Test Patterns for Inner FEC(s)

- Clause 177, 184 and Annex 174A

Comment # 9, 10, 128, 148, 149, 150, 345

Xiang He, Huawei

Figure 177-2—Functional block diagram

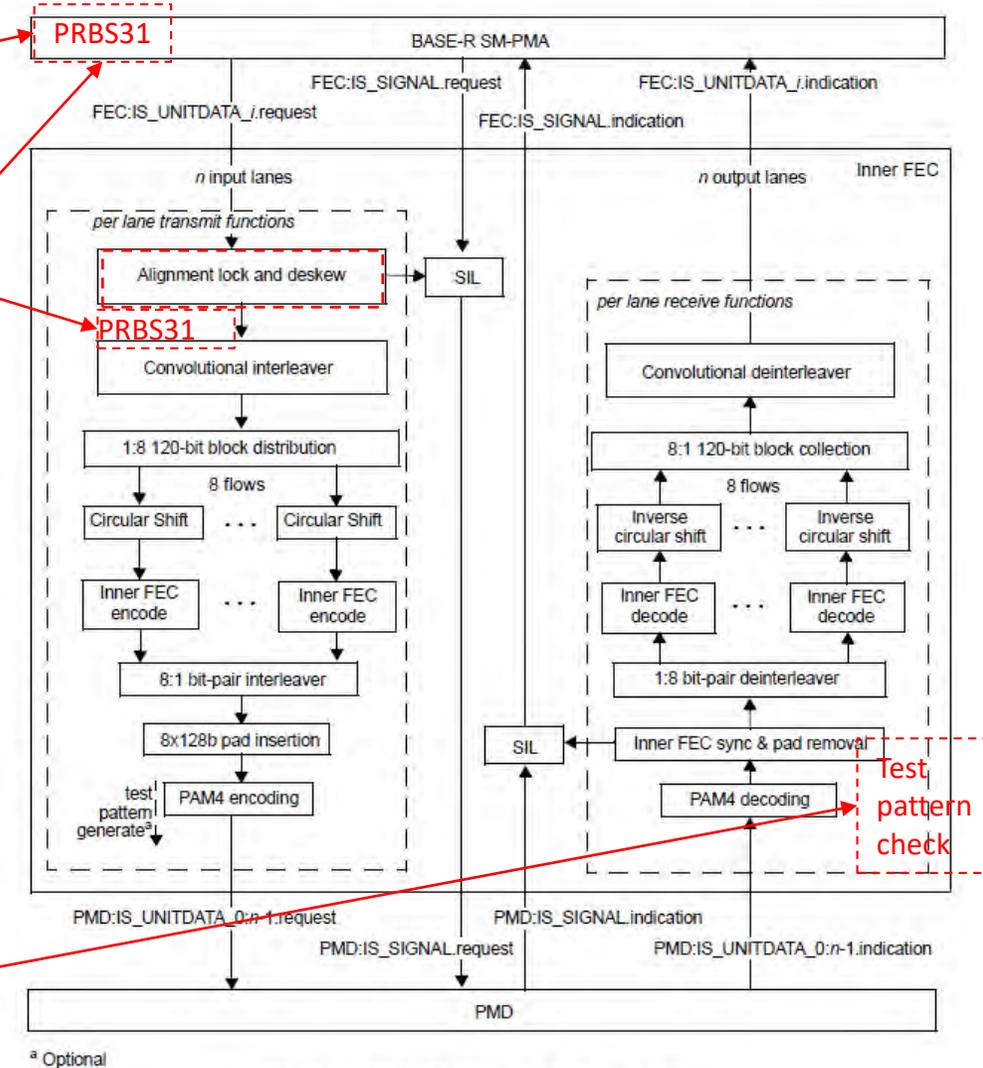
CI 177	SC 177.5.1	P 338	L 27	# 9	CI 177	SC 177.1.4	P 307	L 31	# 148
Brown, Matt		Alphawave Semi			He, Xiang		Huawei		
Comment Type	T	Comment Status	X		Comment Type	TR	Comment Status	X	
In Draft 1.3, PRBS13Q and PRBS31Q generators were added to the Inner FEC transmit path output (see 177.4.9). A checker on the input of the receive path would be helpful for rudimentary testing of a PMD or link.					There should be some test patten checker on the receive path. A contribution will be provided to support this with block diagrams.				
<i>Suggested Remedy</i>					<i>Suggested Remedy</i>				
Add PRBS13Q and PRBS31Q pattern checkers to the input of the Inner FEC receive path.					Add "test pattern check" on the receive path on the PAM4 decode box, similar as in Figure 176-2.

- Add PRBS checker on the Rx

- Proposed changes to Figure 177-2: (#9, #148)

177.5.1 Test pattern checkers:

The Inner FEC may optionally include test pattern checkers for PRBS13Q and PRBS31Q (see Figure 177-2). Hard-decision PAM4 decoding results are used for test pattern checkers.

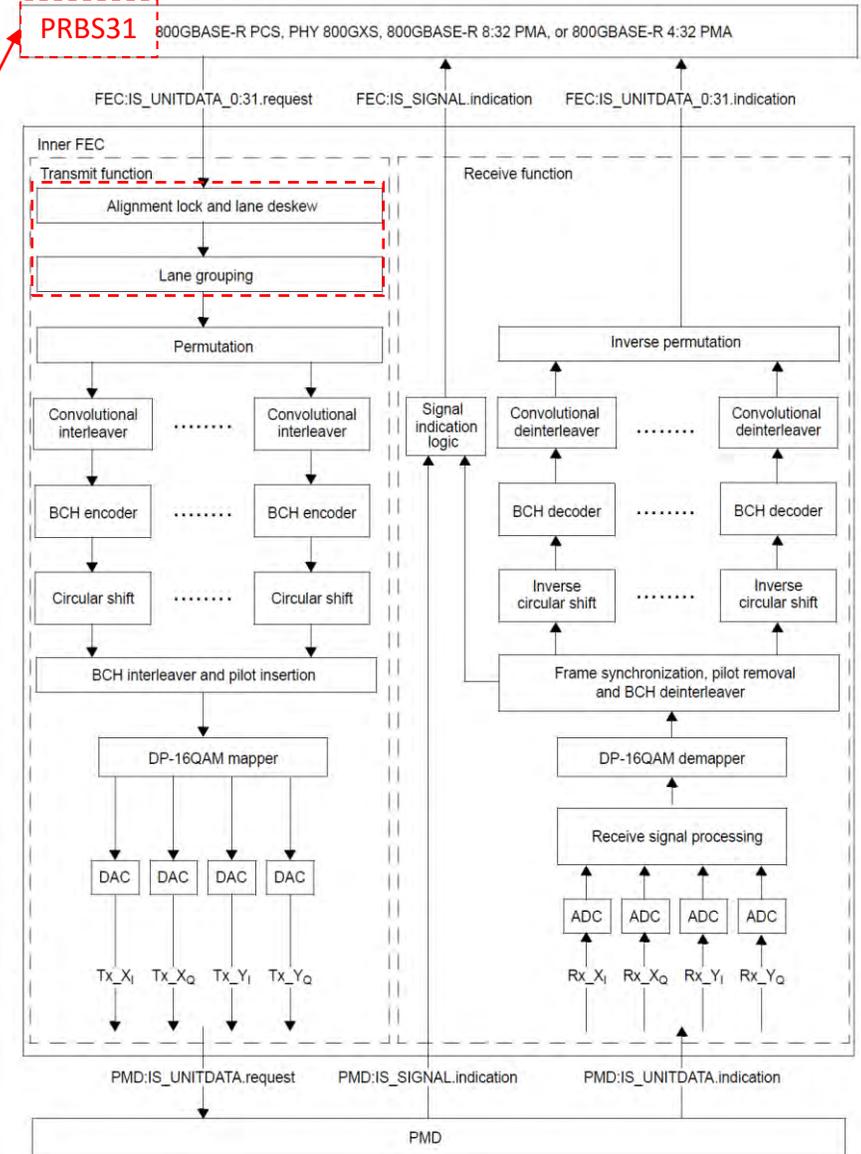
CI 184 SC 184.2 P 517 L 34 # 149

Clause 814 Inner FEC for 800GBASE-LR1 did not include any test patterns.

It is recommended to add at least one test pattern for this clause. Add "Test patten generate" to the DP-16QAM mapper box. Also insert a subclause in 184.4.11 describing the test pattern(s).

- Table 185-10 listed test patterns for Clause 184, but no test patterns were in clause 184.
- Recommend to add a PRBS31 test pattern to test the logic functions.

- When in test mode, “alignment lock and lane deskew” and “lane grouping” are disabled and bypassed.

184.4.12 Inner FEC test patterns

184.4.12.1 PRBS31 encoded by Inner FEC

The Inner FEC may optionally support a test mode, where a PRBS31 test pattern generated from the PMA above (see 176.7.4) is round-robin distributed to `pcsla[q]` for $q=0$ to 31, and then processed by Inner FEC sublayer, with the exception that the “alignment lock and lane deskew” (see 184.4.1) and “lane grouping” (see 184.4.2) functions on the transmit path are disabled and bypassed. On the receive path, the PMA above may detect the PRBS31 pattern recovered by the Inner FEC sublayer.

Figure 174A-2—Test configuration for a PMD with Inner FEC

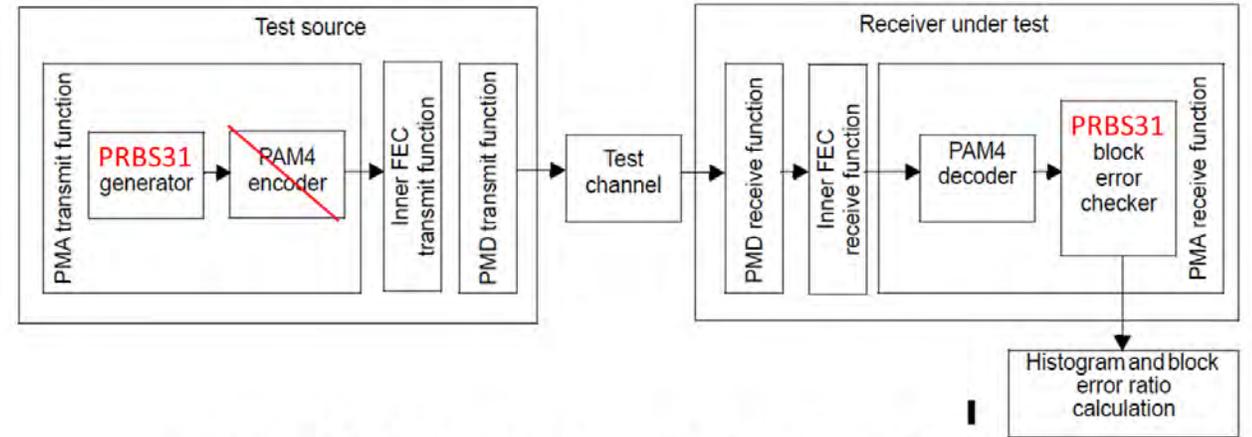
CI 174A	SC 174A.6.1.1	P 663	L 39	# 128
Slavick, Jeff		Broadcom		
Comment Type	T	Comment Status	X	
The CI177 and CI184 Inner FEC blocks are both reliant upon finding the AMs in the data stream to determine the RS-FEC CW boundary. So Figure 174A-2 is not a viable configuration unless that alignment and deskew processes are disabled in a test mode.				
<i>Suggested Remedy</i>				
Add a test_mode to CI177 and CI184 that causes the input to permutation function in CI184 and the input to convolutional interleaver in CI177 to use the PMA service interface input data directly.

The CI177 and CI184 Inner FEC blocks are both reliant upon finding the AMs in the data stream to determine the RS-FEC CW boundary. So Figure 174A-2 is not a viable configuration unless that alignment and deskew processes are disabled in a test mode.

Cl 174A	SC 174A.6.1.1	P 663	L 43	# 150
He, Xiang		Huawei		
Comment Type	TR	Comment Status	X	
The PAM4 encoder should not be in front of the Inner FEC transmit function.				
The PRBS31Q pattern should not go through the Inner FEC transmit function in order to maintain its characteristics.				
A presentation will be provided.				
<i>SuggestedRemedy</i>				
First, remove "PAM4 encoder" box. Then, either change "PRBS31Q" to "PRBS31", or move "PRBS31Q" into the "Inner FEC transmit function" box.				
A presentation will be provided.

- Comment #150 is essentially the same thing as comment #10 but focused on the diagram in 174A.

Add a test_mode to CI177 and CI184 that causes the input to permutation function in CI184 and the input to convolutional interleaver in CI177 to use the PMA service interface input data directly.

Suggested remedies for comment #128, 150

- Change PRBS31Q to PRBS31.
- Remove the “PAM4 encoder” box in the test source.
- In 177.4.2 add this paragraph after the first paragraph:

When in test mode the convolutional interleaver uses the Inner FEC service interface inputs directly. The selection of the 40-bit symbol boundary point is implementation specific.
